Stakeholder Comments Template

System Market Power Mitigation

Submitted by	Organization	Date Submitted
<i>Brian Theaker</i> 530-295-3305	<i>Middle River Power, LLC</i> ("MRP")	<i>January 10, 2020</i>

Figure 3: Percent of Total Hourly Import Offers per Intertie in 2018

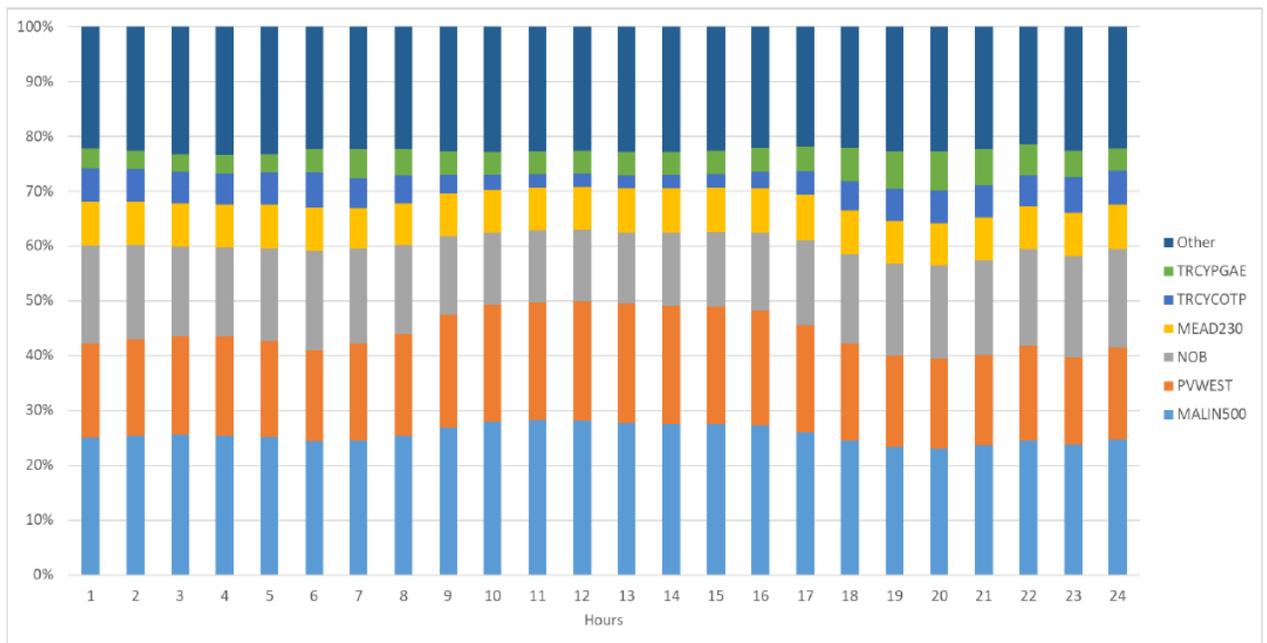
MRP is concerned about the CAISO’s proposal to deem the CAISO Balancing Authority Area (“BAA”) to be “import-constrained” if the Palo Verde (“PV”), Nevada-Oregon Border (“NOB”) and California-Oregon Boarder (“COB”) import paths are simultaneously constrained. While the CAISO report that the PV, NOB and COB paths were simultaneously constrained for only one 15-minute interval in 2018, the CAISO also reported that only 60% of import offers were associated with these paths, as shown in Figure 3 taken from page 24 of the Straw Proposal below:

While the majority of 2018 import offers were associated with these paths, that majority still comprises only 60% of all import offers. While, based on the 2018 experience, it seems likely that these three paths would be simultaneously constrained only in a very few real-time intervals, a significant amount of import capability is not associated with these three paths, and deeming the CAISO to be import-constrained when these three paths are simultaneously constrained would be an overly conservative approach. If the CAISO is

going to consider its entire BAA to be “import constrained” when only a subset of import paths are simultaneously constrained, the CAISO should consider a subset of paths that reflects a much higher percentage of import offers than the modest 60% captured in the three proposed paths.
